**BSR/ASHRAE/IES Addendum v  
to ANSI/ASHRAE/IES Standard 90.1-2022**

# **Proposed Addendum v to Standard 90.1-2022, Energy Standard for Sites and Buildings Except Low- Rise Residential Buildings**

**First Public Review (February 2024)  
(Draft Shows Proposed Changes to Current Standard)**

2021 ASHRAE 169 vs 2013 US Climate Zone Changes  
(3092 Total US Counties)

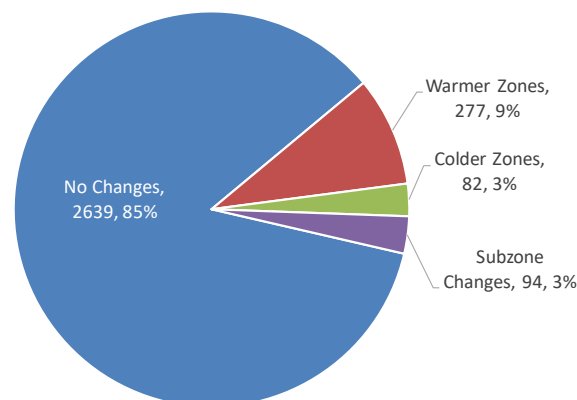
We have conducted an analysis of the climate zones for the 3092 US counties and found the following results where some counties moved to warmer climate zones, some moved to colder, and some changed subzones.

This addendum is just a reference update and does not impact cost. Some cities may change climate zones to either warmer, cooler or subzones changes which could impact requirements in the ASHRAE 90.1 standard.
